MEMORANDUM TO PLANNING COMMISSION

DATE: October 14, 2020
FROM: Tanya Rice, Planner II
SUBJECT: **100 W. Apartments Site Plan and Elevations**

**Project #20-051
100 West Apartments
Located at 162 South 100 West**

A3 NORTH ELEVATION
SCALE 1/8" = 1'-0"

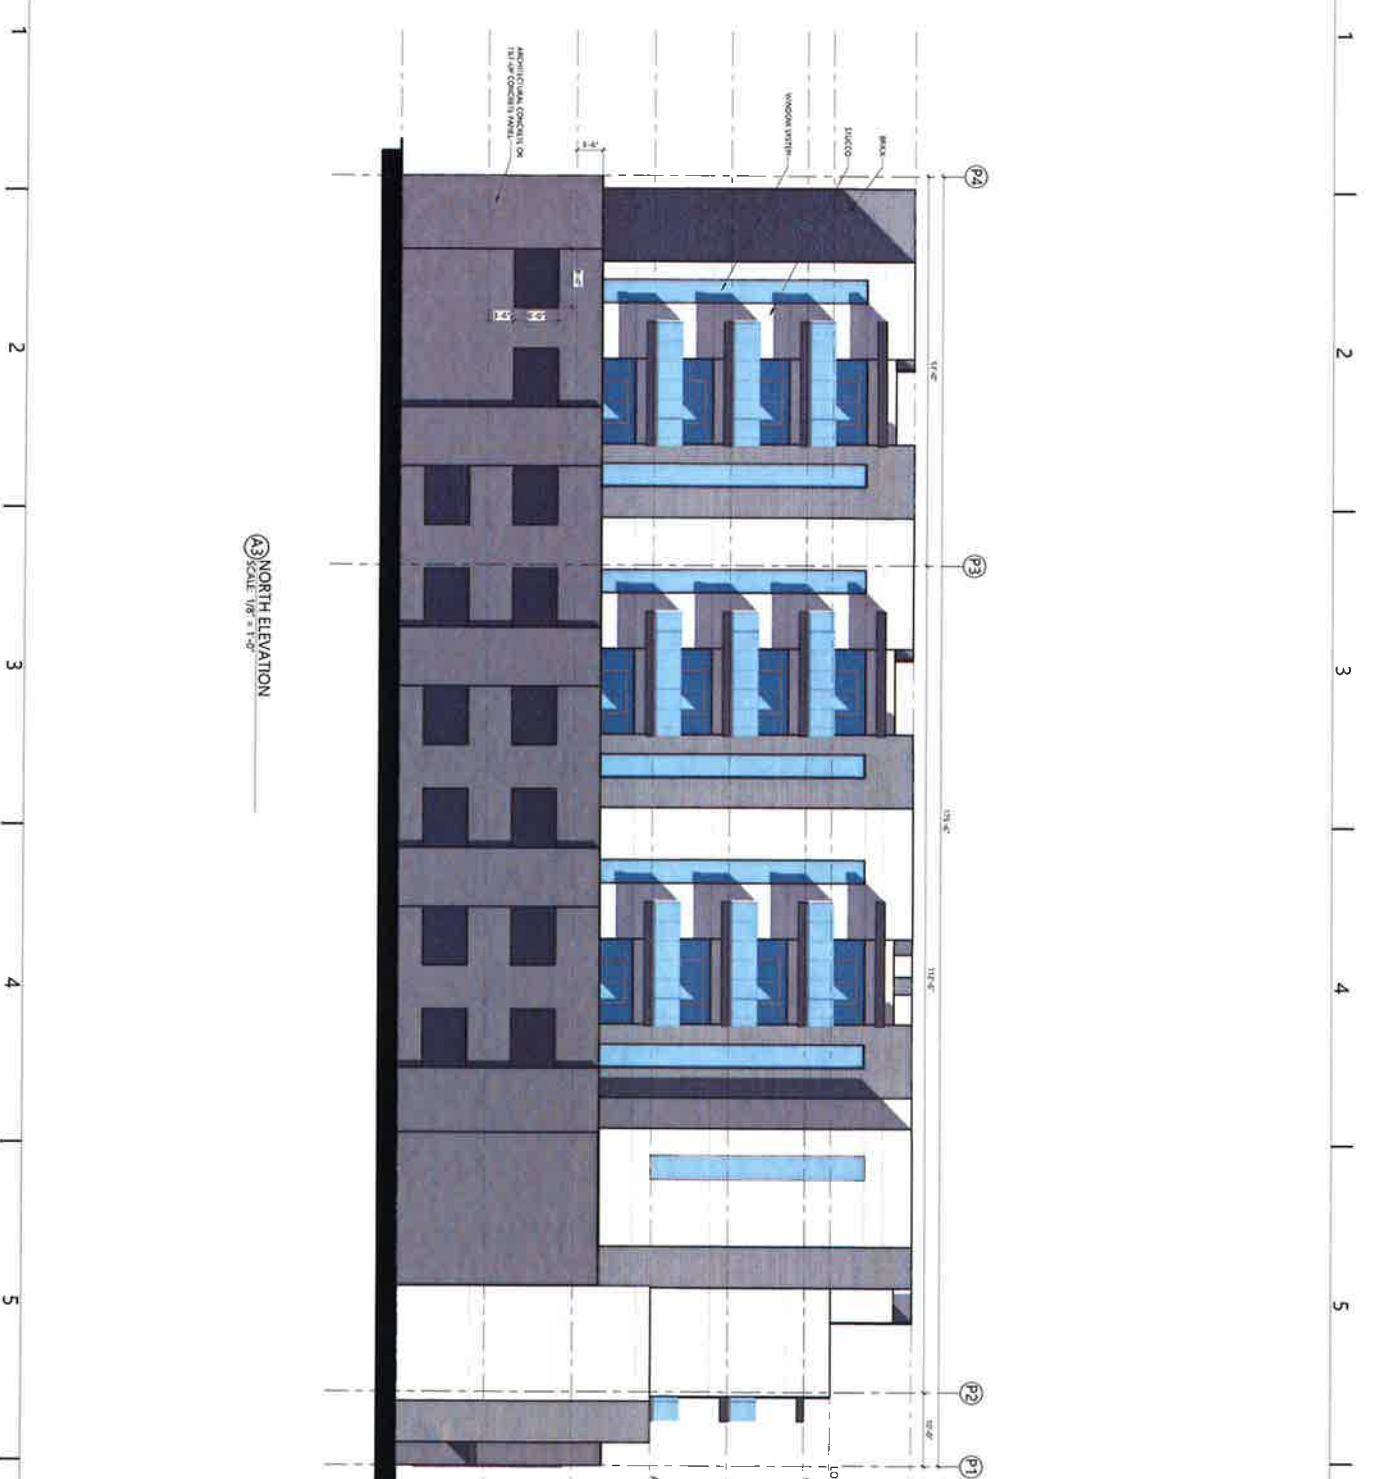
1. Four visitor parking stalls (for 37 units) are not shown.
2. Screens on parking structure on north and south elevations are not shown.

12. Screen parking structure openings on north and south elevations with architectural metal panels, louvers, or remove windows.
13. Exterior lighting shall be concealed source, down-cast and reviewed and approved prior to the issuance of a building permit and shall comply with current LDC regulations.

ARCHITECTURAL
SITE PLAN
AS101

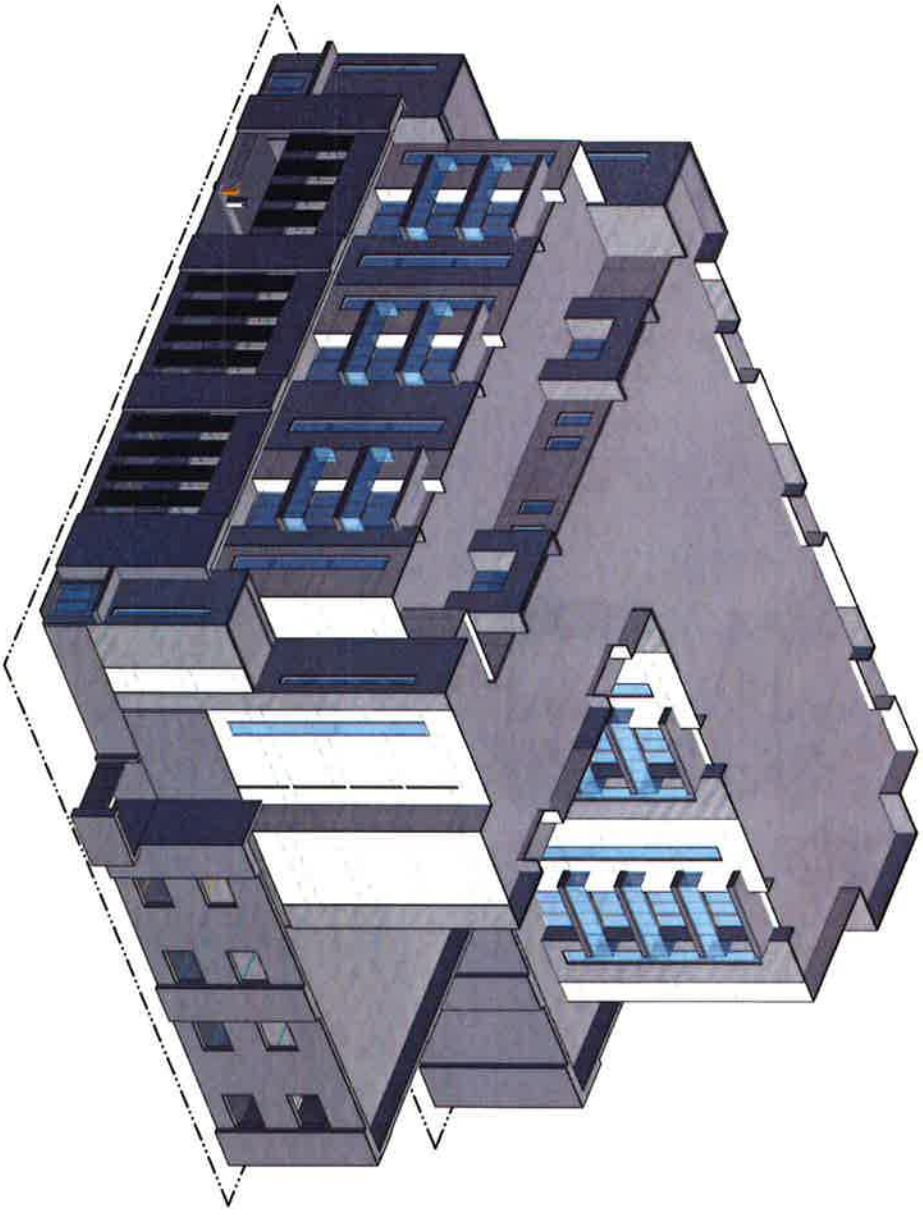
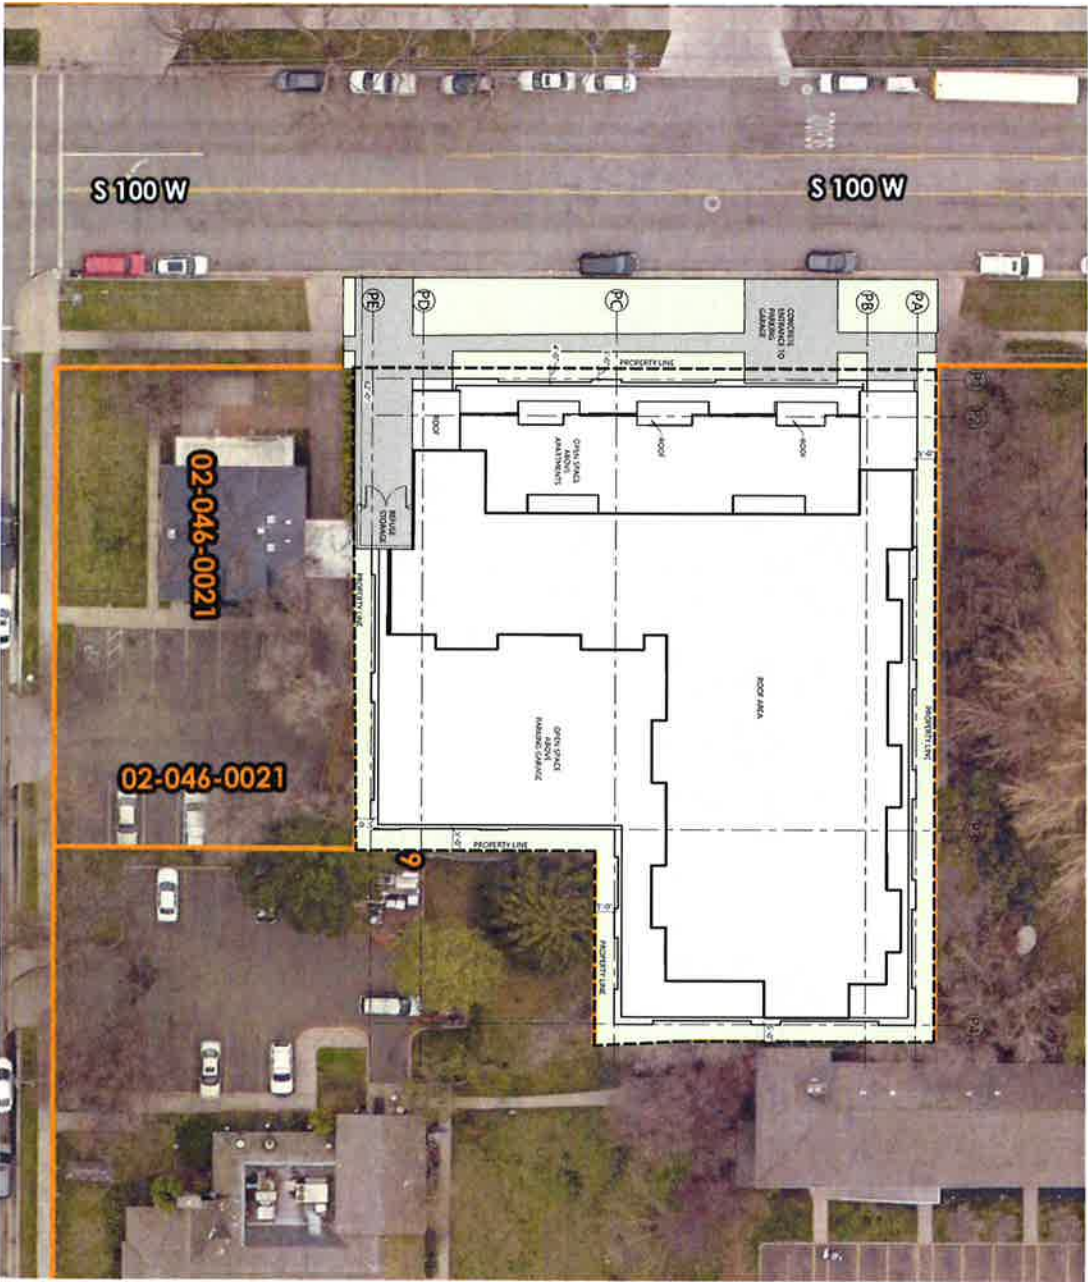
1. The refuse storage is located on the south side of the property as shown.
2. Designated bike parking to accommodate 37 bikes is located in the southeast corner on both levels of the parking structure as shown.
3. Revised setbacks to 5' around the perimeter of the building except the front (west), showing 4' from the property line (3' in front of architectural metal panels).
4. Architectural concrete detail identified as tilt-up concrete panel (precedent image attached).
5. Delineation of the three levels of the building to break up the blank wall flatness is shown with vertical architectural detail and bump-outs, added vertical windows, and material variation.
6. The number of resident parking stalls remain at 74 to reflect the 37 2-bedroom units.
7. Covered pedestrian entrances.
8. Parking structure entry gates with key pad locations.

3. Final floor plans of all residential units shall be provided to Community Development to verify unit count and configuration.
4. The Planning Commission permits the setback along 100 W to be 4' except for the space in front of the architectural panels.

5. The Planning Commission permits the 5' setback along the north, south and east property lines.
6. The project shall provide 78 parking stalls (proposed 74). Four (4) additional parking stalls shall be provided for visitors and constructed in accordance with LDC dimensional size standards and specifications.
